Checklist for P.E. Annual Inspection for CCR Surface Impoundments, § 257.83(b)

Sikeston BMU Sikeston Power Station Fly Ash Surface Impoundment

Annual Inspection

**2019 INITIAL ANNUAL P.E. INSPECTION
FLY ASH POND
SIKESTON POWER STATION**

FIGURE 1

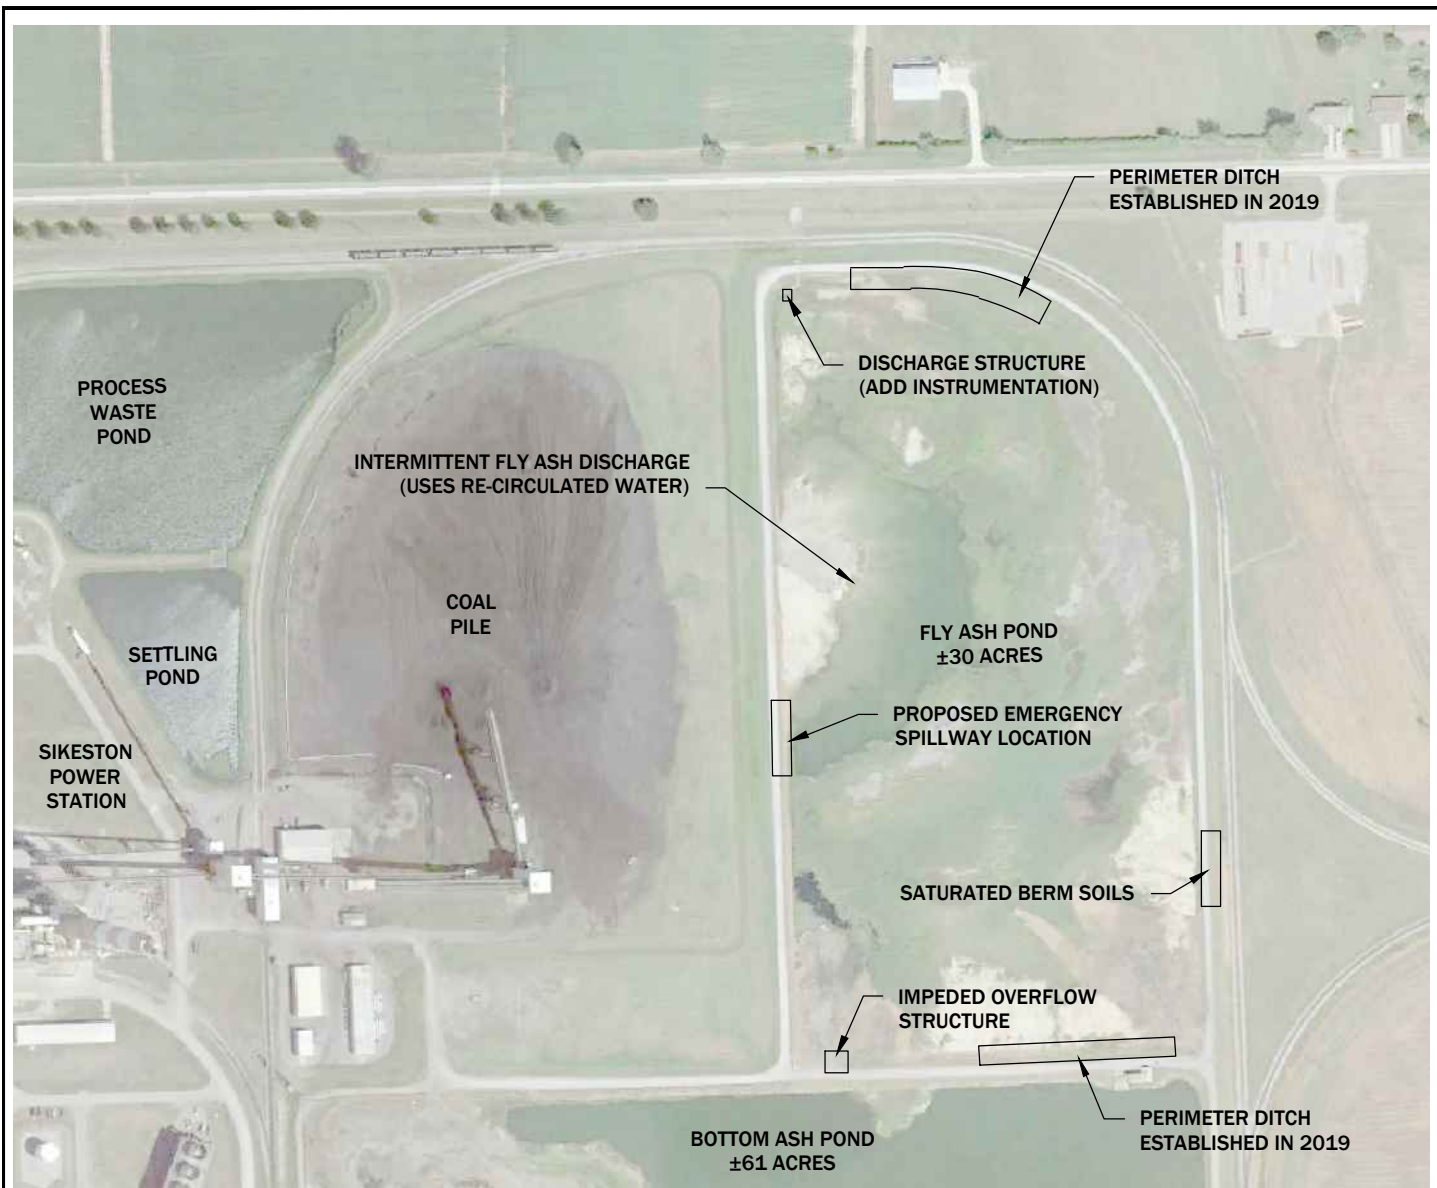
1. The location of observations on attached plan sheet (Figure 1).

1. MINOR MAINTENANCE ITEMS INCLUDE:
 - a. CLEAN SEDIMENT AND VEGETATION FROM DISCHARGE STRUCTURE.
 - b. ADD INSTRUMENTATION (STAFF GAUGE).
 - c. REPAIR INOPERABLE GATE VALVE TO THE PROCESS WATER POND OR DEVELOP AN EMERGENCY SPILLWAY.
 - d. EXCAVATE STORMWATER CHANNEL 2 FEET DEEP ALONG POND PERIMETER (WHERE REQUIRED)

2. REQUIRING FURTHER OBSERVATION INCLUDE:
 - a. SATURATED BERM SOIL ALONG SOUTHEAST BERM.

3. ITEMS IDENTIFIED DURING THE INITIAL INSPECTION WHICH DO NOT REQUIRE MAINTENANCE INCLUDE:
 - a. THE IMPEDED OVERFLOW STRUCTURE BETWEEN THE BOTTOM ASH POND AND THE FLY ASH POND.
